PPP-P-704E
AMENDMENT-2
February 20, 1987
SUPERSEDING
AMENDMENT-1
December 28, 1983

FEDERAL SPECIFICATION

PAIS, METAL: (SHIPPING, STEEL, 1 THROUGH 12 GALLONS)

FIG 9 A PRESS-IN TYPE PLASTIC NOZZLE AND CAP CLOSURE
WITH PLASTIC PUSH-FILL SPOUT

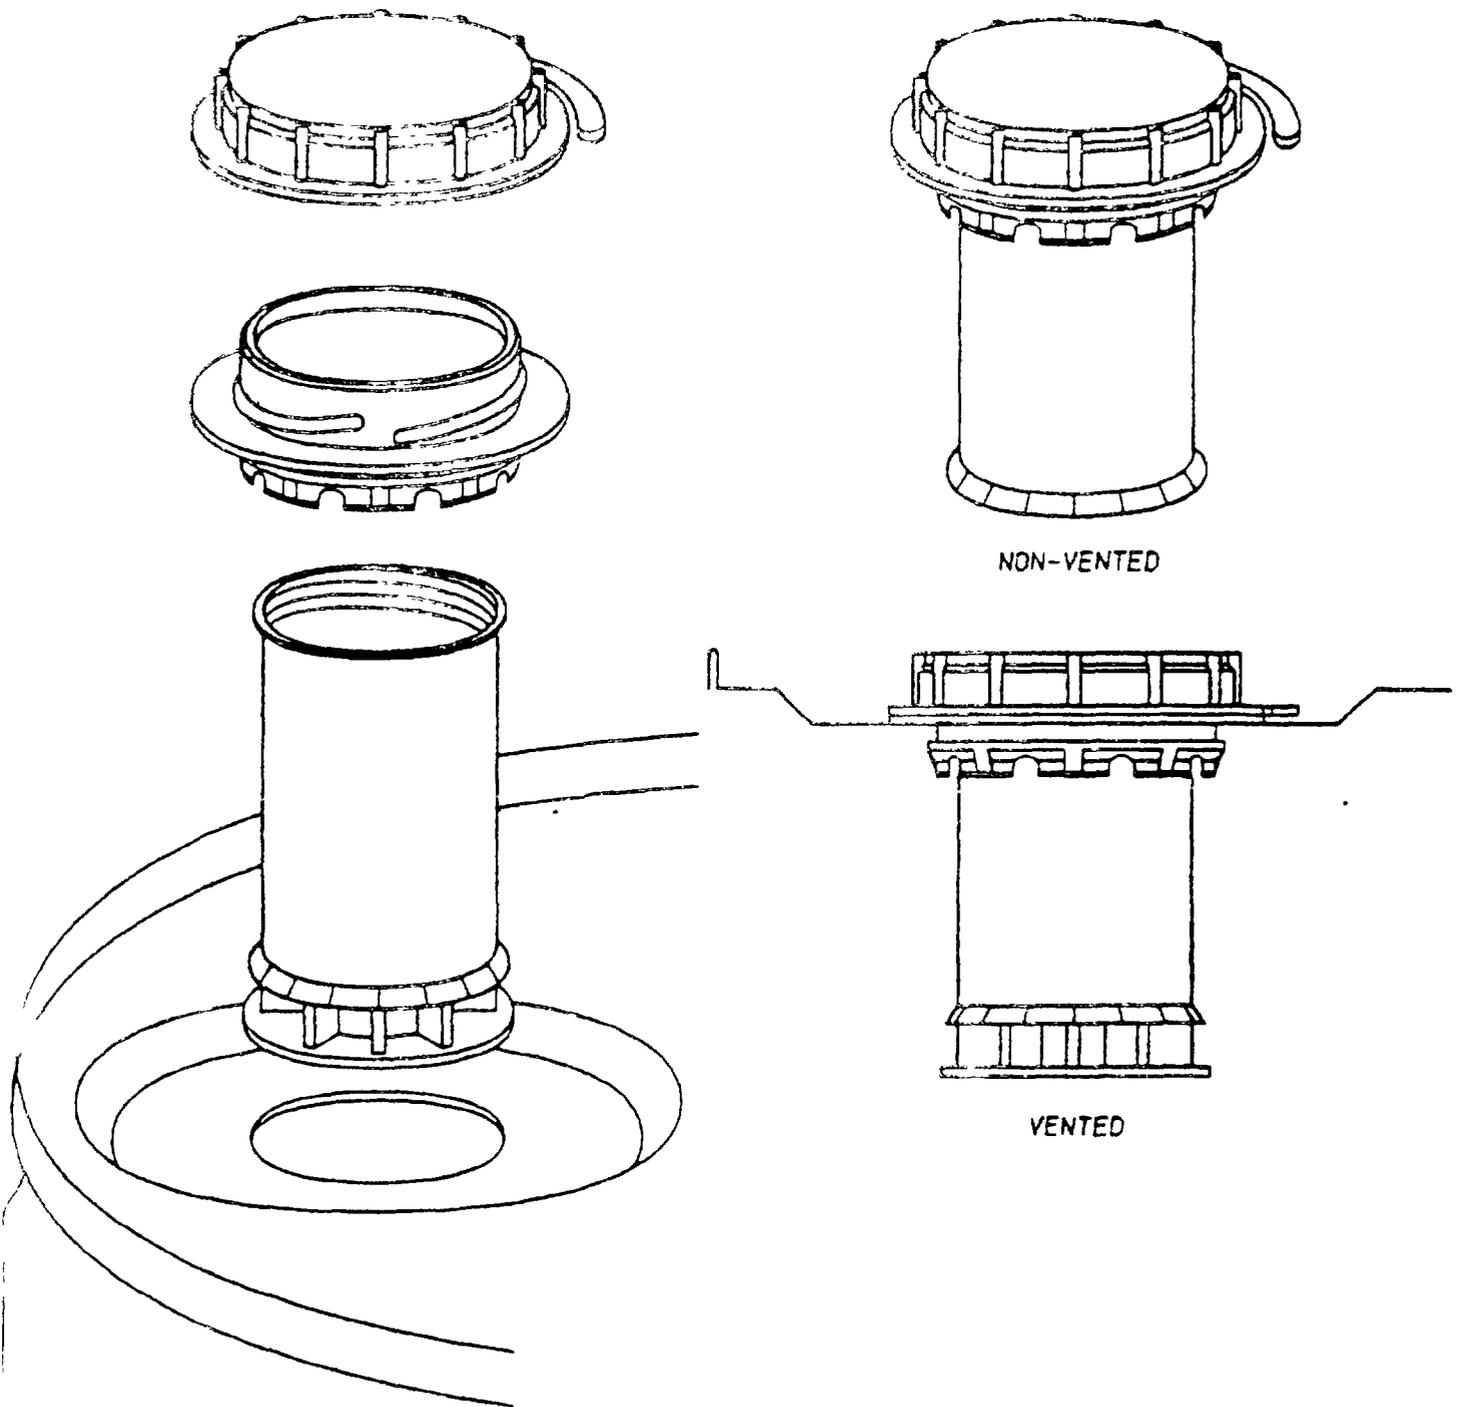
After 3.1.4.1 add:

"3.1.4.1.1 Press-in pull-up closure with screw cap with integral tamper evident seal (see figure 9A). The press-in pull-up closure with screw cap with integral tamper evident seal shall be molded of commercial quality polyethylene or comparable functioning plastic. The closure shall be designed to be pressed into the opening in the pail top. The closure shall have the flanges of its neck and its cap fused together in such a way as to form a leak-proof and tamper evident seal. A pull-tab shall be provided on the cap flange for removal of the tamper evident seal. The closure shall have a pouring opening of not less than 1-1/2 inches in diameter. The closure shall include a pull-up pouring spout, either self-venting or non-venting (see 6.2), and molded of commercial quality polyethylene or comparable functioning plastic. The spout shall be able to be raised to fully extended pouring position after removal of the tamper evident seal by means of the screw-cap which is screwed into the pull-up spout. The spout, in extended pouring position, shall tightly engage within the nozzle opening."

FIGURE 10 - COLLAPSIBLE SPOUT

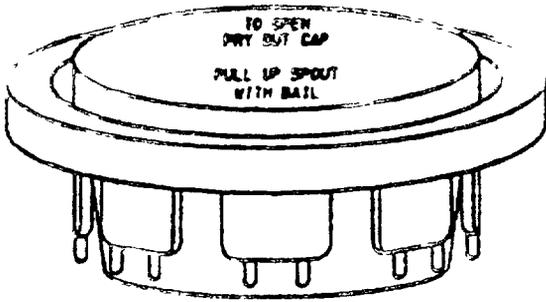
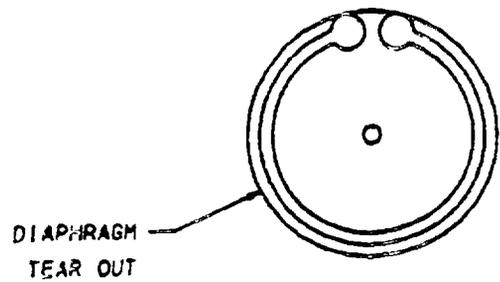
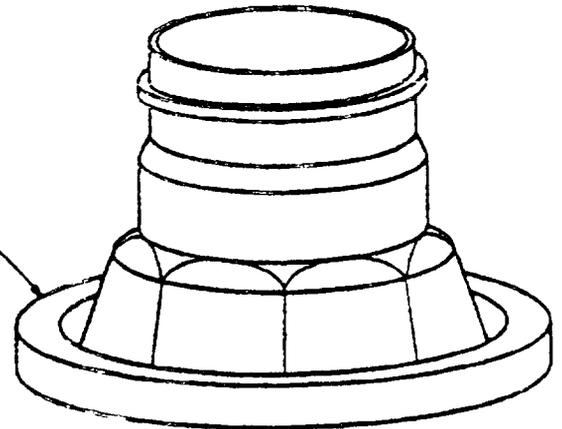
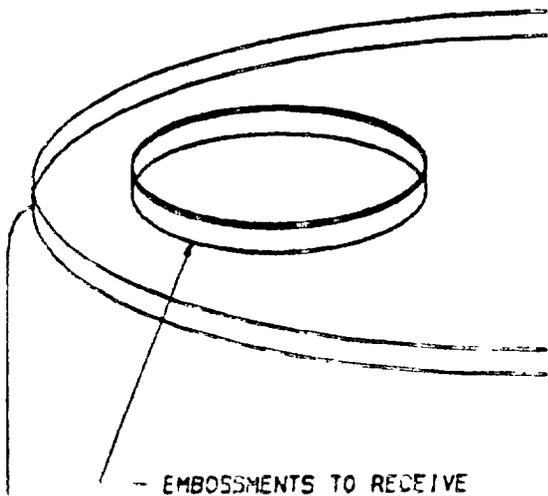
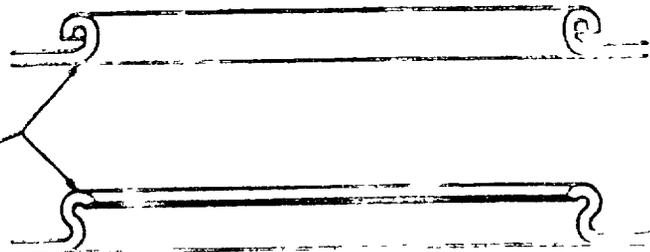
3.1.4.9.3: Delete and substitute:

"3.1.4.9.3 Collapsible spout closure. Collapsible spout closure shall be molded of commercial quality polyethylene or a comparable functioning plastic. A tear out diaphragm of the same material shall be molded as an integral part of the pouring spout. The portion of the closure attached to the container shall be molded so as to fit on the outside diameter of the sealing portion of the preformed opening in the container head prior to being clinched. The preformed opening shall provide an opening in the container of approximately 2-3/8 inches to receive the collapsible spout closure. The pour spout shall be collapsed inward and shall be pliable so that it may be extended upward from collapsed position to pouring position. The pouring end of the spout shall have male threads and shall be fitted with a plastic screw cap made of polyethylene or comparable functioning material for reclosing. The plastic screw cap shall have one or two bails or other suitable finger grips for lifting the spout into a pouring position. The bails or finger grips shall be molded as an integral part of the cap (see figures 10 and 20)".

Figure 10: Delete in entirety, add new figure 10 (attached).

FIGURE 20 - COLLAPSIBLE SPOUTS

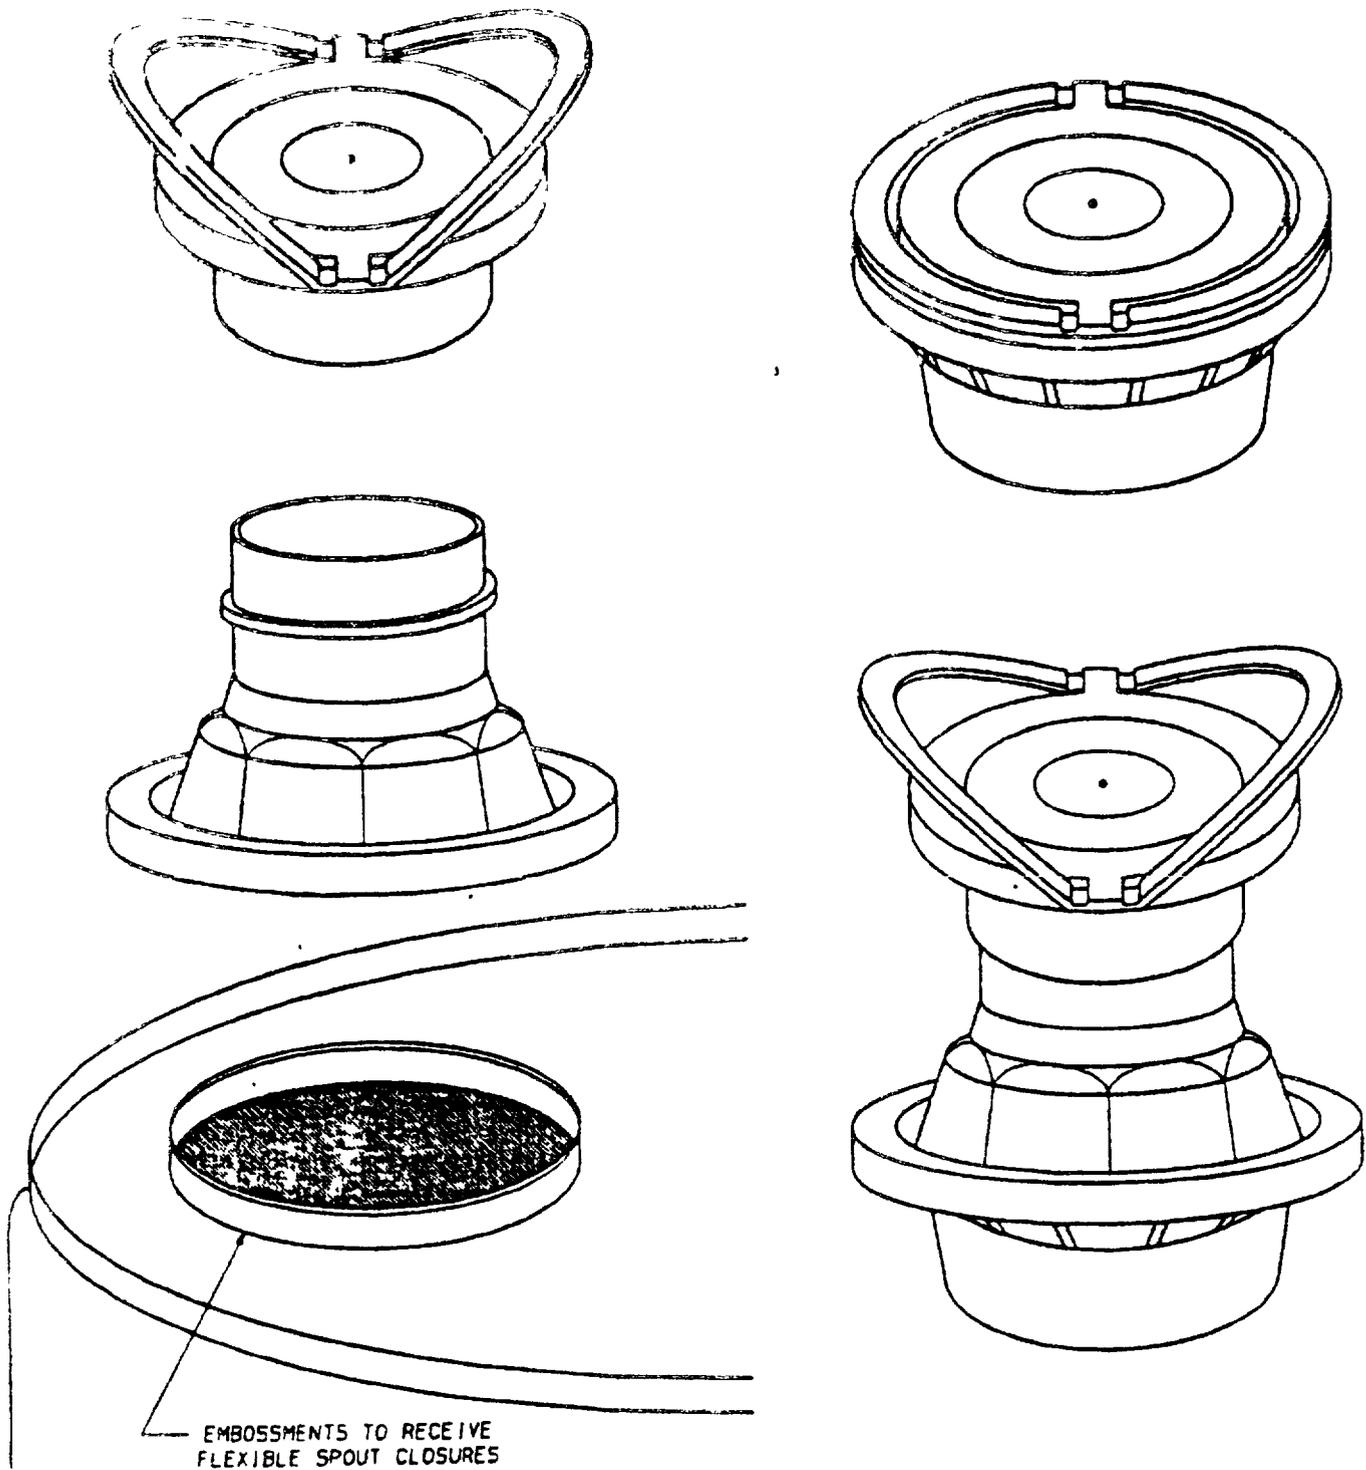
3.1.4.5, line 2: Delete "18" and substitute "20".
line 20: Delete "flexible" and substitute "collapsible".
line 20 after "figure 10": add "and 20".
line 21: Delete ", and 18".

3.1.4.8, line 4: Delete "and 14" and substitute "14, and 20".

3.1.4.9.4, last line: Delete "(see figure 10)" and substitute "(see figures 10 and 20)".
